INDIANA DEPARTMENT OF TRANSPORTATION

NOTICE OF PROJECT ADVANCEMENT – DES#s 1900308 (Lead), 1900264, 1500041, 1600060, 1602258, 1702066, 2001917, 2100041, 1900262, 1900258, 1900260, 2301254 (Lead), 1900263, 2000187

SR 62 Road Reconstruction, Intersection Improvements, and Bridge Replacements from Rosenberger Avenue (4.59 Miles West of S Jct US 41) to 2.72 Miles West of S Jct US 41 (Wabash Avenue), Vanderburgh County.

Public Hearing Comments and Responses

RED BANK ROAD INTERSECTION

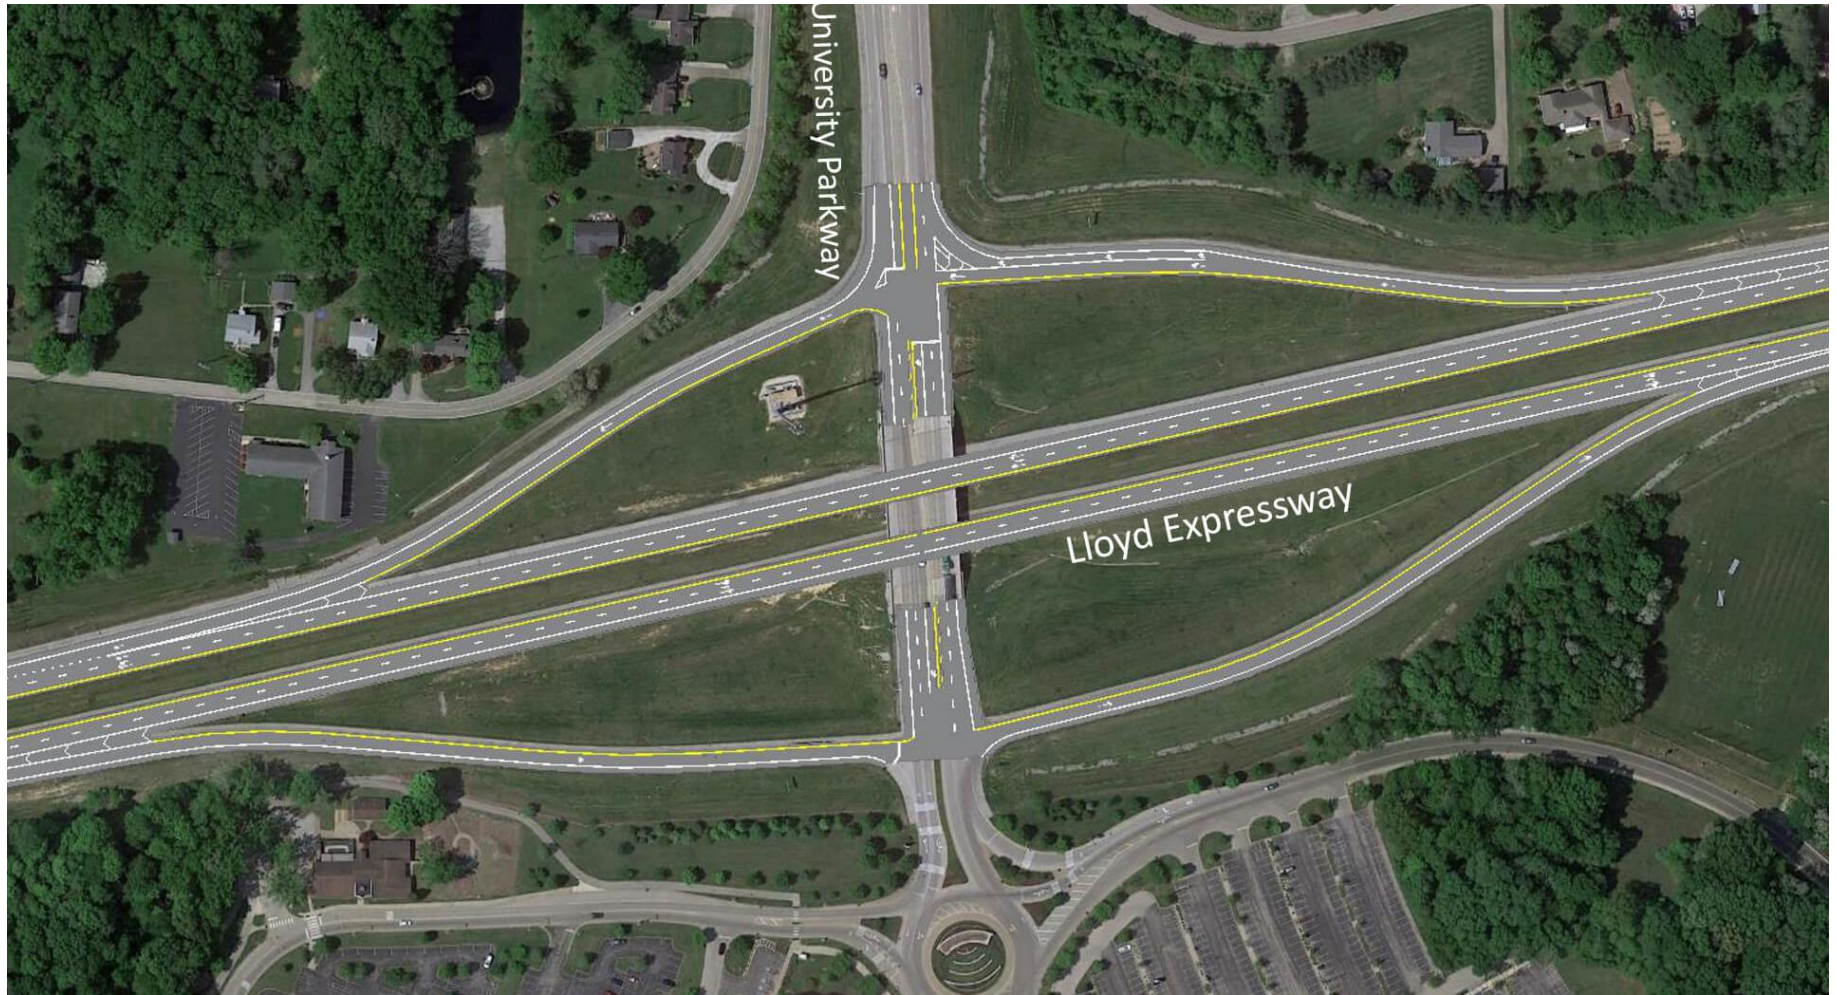
18	DLT at Red Bank	I'm concerned about the intersection at the Red Bank Road and Lloyd with the displaced turning lane because I've sat at that intersection with two left-turn lanes that exist now and had to sit through four or five light changes to get through that intersection to get to Walmart Super Center, and now you're changing it to the displaced single lane left turn, and that traffic is going to be backed out of that single lane onto the double lane that's heading west, and it's going to obstruct the traffic, is my concern. That the traffic is not going to be able to get off the road into that single lane because of all the traffic that's going in because you have the Walmart, we have Home Depot, you have the cinema complex, and all the restaurants along Pearl Drive there that people are trying to access. There's a lot of traffic that's trying to get through, and people run that red light now all the time because they get tired of waiting in the two lanes, and you're converging it into one diverted left lane, and I'm afraid that the traffic is going to be backed out on the highway, impeding the flow. And that's the only comment I have. Okay. Thank you.	A. Can traffic be accommodated by a single displaced left turn lane when there are currently two left turn lanes to go from WB Lloyd to SB Red Bank?	A. Yes. The displaced left turn intersection configuration allows for more green time to be allocated to the mainline left turn movements. This allows for a reduction in turn lanes while maintaining adequate LOS for the movement.	9/26

CORBIERRE AVENUE INTERSECTION

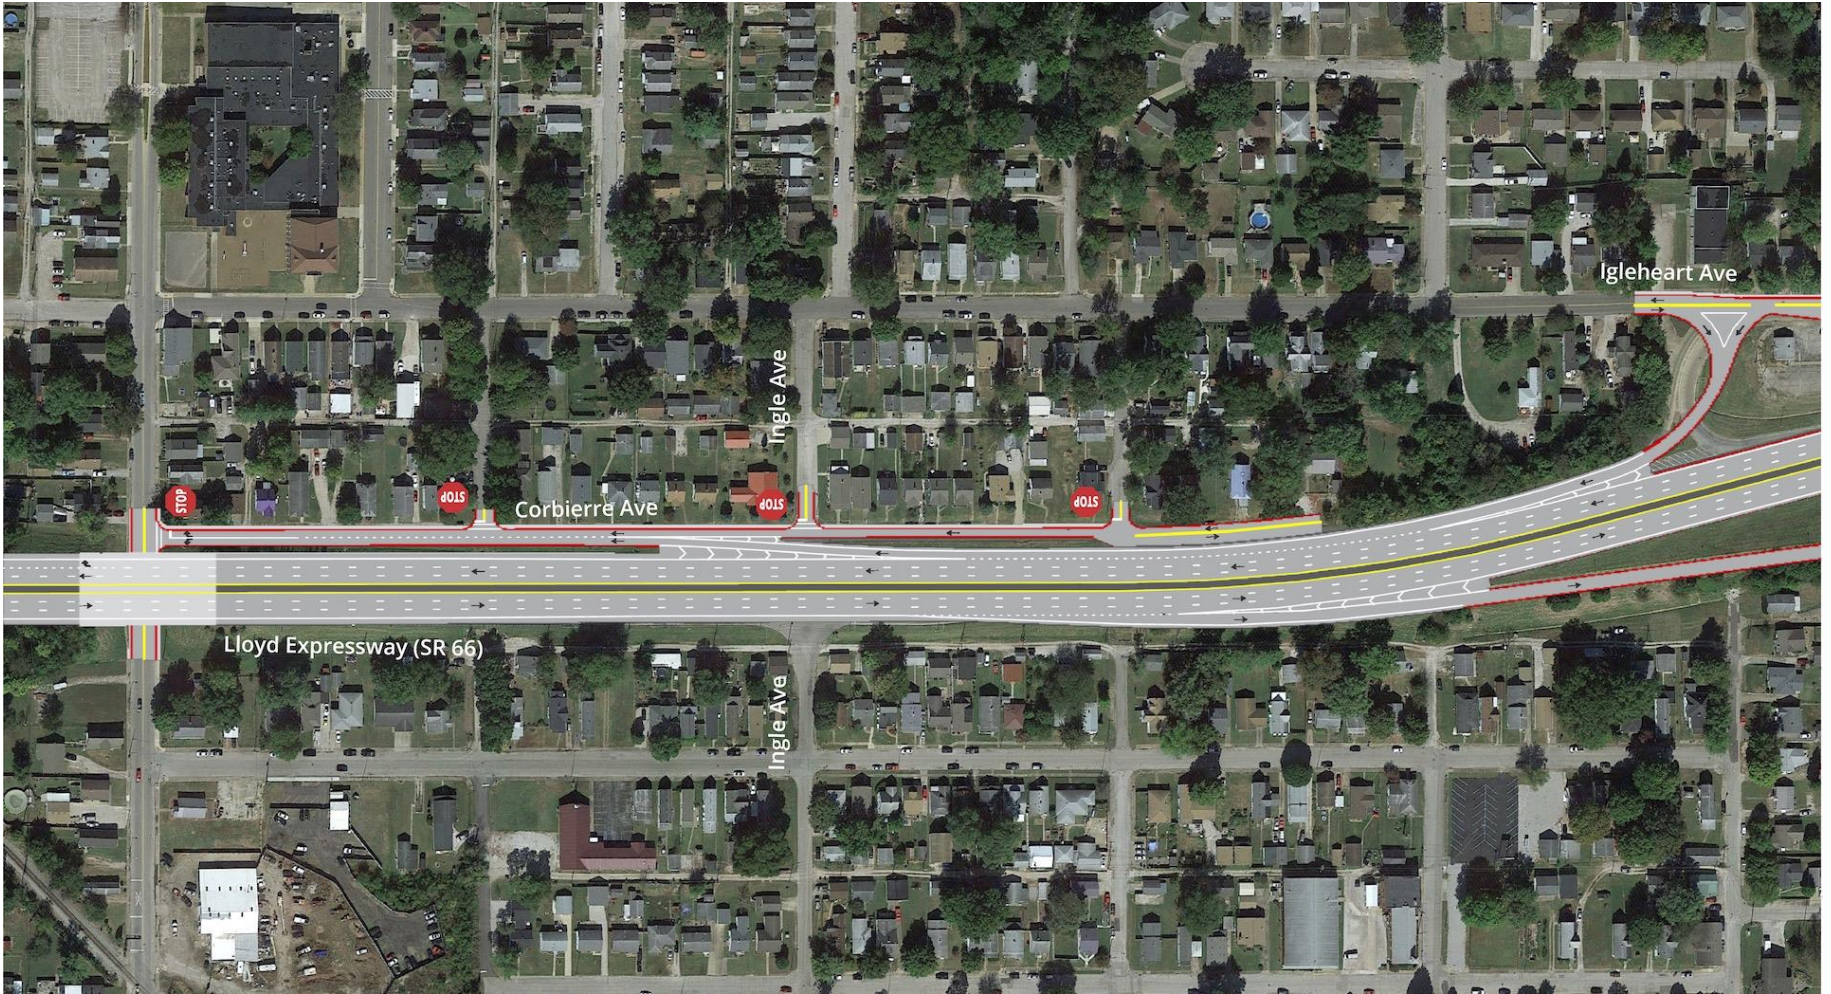
7	Sound Barrier on Corbierre	<p>Why does this project not include sound barriers for those residing on Corbierre Avenue? The noise pollution is already substantial and the addition of extra lanes to the Lloyd Expressway, as well as Corbierre Avenue, will be exponential. The other side of the Lloyd, those who live on Forest Avenue, are getting a sound barrier and have more room away from the highway as it stands including more grass area and an alley.</p> <p>I thank you for your time and consideration. As a resident of Corbierre Avenue this is something I feel needs that needs addressed before undertaking this project Spring 2024. I hope you find this comment well and address it at this presentation.</p> <p>Best, Rachel Thomas</p>	A. Why does Forest Ave. get a sound barrier and Corbierre does not?	A. The noise analysis included the residences north of the Lloyd Expressway between Tekoppel Avenue and Barker Avenue and concluded that many of the properties along Corbierre Avenue would experience noise impacts as defined by FHWA and INDOT noise policy. Subsequently, noise abatement barriers were given consideration for this area. However, unlike the south side of the Lloyd Expressway, placement of a continuous barrier with no breaches along the portion of the highway would not be feasible since the westbound traffic exit ramp to Tekoppel Avenue via Corbierre Avenue would require a large gap in the barrier. Two shorter length barriers east and west of the exit ramp gap were modeled to a height of 18 feet to evaluate noise reduction effectiveness for the Corbierre Avenue residents. The length and position of the barriers was limited by the need to maintain clear zone design standards. While these barriers were predicted to provide 5 to 7 dBA noise reduction for a few residences along Corbierre Avenue, the magnitude of the benefits do not meet the INDOT policy criteria for feasible and reasonableness. Based on this analysis, a feasible and effective barrier is not possible for this location. Construction of an effective noise barrier between the Lloyd Expressway and Corbierre Avenue residences would require eliminating the westbound exit ramp to Corbierre Avenue that provides access to Tekoppel Avenue. Closing the westbound exit ramp to Corbierre Avenue would result in drivers utilizing the westbound exit ramp to Barker Avenue then continue along Igleheart Avenue to	9/26

Theme	Comment	Summary Points	Response	Date
11	Speed on Tekoppel exit	We think rumble strips need to be added to Corbierre Ave from the Ingle to Tekoppel to decrease speed coming off the Lloyd. Currently the speed limit along Corbierre is 30 moh. People drive past my house at speeds in excess of 50 mph.	A. Add rumble strips to Corbierre.	A. Rumble strips make a loud noise when vehicles run over them and therefore are not recommended in a residential area. A merge lane will be constructed between the Igleheart entrance ramp and the Tekoppel Exit Ramps for drivers to slow down before exiting onto Corbierre.	9/26
12	Coordination of changes on maps	Coordinate with Google/Apple maps throughout the project to keep GPS maps accurate. Thank you. Great ideas, great project, great presentation!	A. Coordinate changes with Google/Apple B. Approves of project	A. The project team is looking at best practices for keeping popular applications updated of closures and detours during construction. Signing up for text alerts or emails will also help drivers manage changes during construction. B. Noted	9/26

20	Noise on Corbierre	I personally am a resident at Corbierre Avenue. I don't know why we weren't necessarily consulted as well as the people who live on Forest Avenue about a sound blockage. The noise pollution is already pretty awful. I just don't know why we were not consulted with that when the front of our houses are basically right next to the Lloyd Expressway. You're expanding on that, and expanding Corbierre as well. It's just going to lead to more noise pollution. I think a sound barrier would be something worth, too, considering. I don't know why the residents weren't consulted. People who live on Forest, they have a little bit more grass area -- they have more grass area, their garages are right there. We live right on top of it. That's my main comment. Thank you.	A. Why were residents on Corbierre not consulted with about a noise barrier?	A. A meeting was held for Corbierre Avenue residents on August 10, 2022 to discuss potential impacts to property owners and review the proposed improvements. That meeting included discussions about repaving, added sidewalks that could impact parking, and access changes. A noise barrier for the Corbierre Avenue residents wasn't discussed because noise analysis wasn't complete. The noise analysis included the residences north of the Lloyd Expressway between Tekoppel Avenue and Barker Avenue and concluded that many of the properties along Corbierre Avenue would experience noise impacts as defined by FHWA and INDOT noise policy. Subsequently, noise abatement barriers were given consideration for this area. However, unlike the south side of the Lloyd Expressway, placement of a continuous barrier with no breaches along the portion of the highway would not be feasible since the westbound traffic exit ramp to Tekoppel Avenue via Corbierre Avenue would require a large gap in the barrier. Two shorter length barriers east and west of the exit ramp gap were modeled to a height of 18 feet to evaluate noise reduction effectiveness for the Corbierre Avenue residents. The length and position of the barriers was limited by the need to maintain clear zone design standards. While these barriers were predicted to provide 5 to 7 dBA noise reduction for a few residences along Corbierre Avenue, the magnitude of the benefits do not meet the INDOT policy criteria for feasible and reasonableness. Based on this analysis, a feasible and effective barrier is not possible for this location. Construction of an effective noise barrier between the Lloyd Expressway and Corbierre Avenue residences would require eliminating the westbound exit ramp to Corbierre Avenue that provides access to Tekoppel Avenue. Closing the westbound exit ramp to Corbierre Avenue would result in drivers utilizing the westbound exit ramp to Barker Avenue then continue along Igleheart Avenue to access Tekoppel Avenue. Igleheart Avenue is a 28 ft wide residential street with street parking on both sides of the road that prohibits continuous two-way traffic. Additionally, Tekoppel Elementary School is located at the corner of Tekoppel Avenue and Igleheart Avenue. Closing the Corbierre Avenue exit would create additional traffic delays and congestion at the Barker Avenue intersection; create additional safety hazards along Iglehart Avenue; and create additional traffic in a school zone. For these reasons closing the Corbierre Avenue exit ramp is not considered a prudent option. Had the noise analysis determined that a sound barrier was feasible and reasonable, a second meeting with residents would have been scheduled to measure interest in a barrier.	9/26

32	Corbierre Sound Barrier	To whom this may concern, As of now the individuals overseeing and planning the LLOYD4U project are considering a sound barrier/blockade for the residents living on Forest Avenue. However, these same people are not extending the same courtesy to the people who live with houses on Corbierre Avenue. Those of us living on Corbierre Ave. and those living on streets close by could greatly benefit from some form of noise reduction as well. The noise pollution from the Lloyd expressway is abysmal. Speaking to Nichole Minton, one of the leading people on the Lloyd4You project, claimed that they are supplying the side closest to Forest Avenue based on a sound survey. I work in a lab so as a self-proclaimed woman of science, I personally love statistics and data, but the people working on this project do not live in this neighborhood. I have lived and owned my home on Corbierre Avenue	A. Why does Forest Avenue get a sound barrier and Corbierre does not? B. Will noise bounce off the noise barrier and create greater impacts to Corbierre residents? C. Will another noise analysis be	A. The noise analysis included the residences north of the Lloyd Expressway between Tekoppel Avenue and Barker Avenue and concluded that many of the properties along Corbierre Avenue would experience noise impacts as defined by FHWA and INDOT noise policy. Subsequently, noise abatement barriers were given consideration for this area. However, unlike the south side of the Lloyd Expressway, placement of a continuous barrier with no breaches along the portion of the highway would not be feasible since the westbound traffic exit ramp to Tekoppel Avenue via Corbierre Avenue would require a large gap in the barrier. Two shorter length barriers east and west of the exit ramp gap were modeled to a height of 18 feet to evaluate noise reduction effectiveness for the Corbierre Avenue residents. The length and position of the barriers was limited by the need to maintain clear zone design standards. While these barriers were predicted to provide 5 to 7 dBA noise reduction for a few residences along Corbierre Avenue, the magnitude of the benefits do not meet the INDOT policy criteria for feasible and reasonableness. Based on this analysis, a	10/10
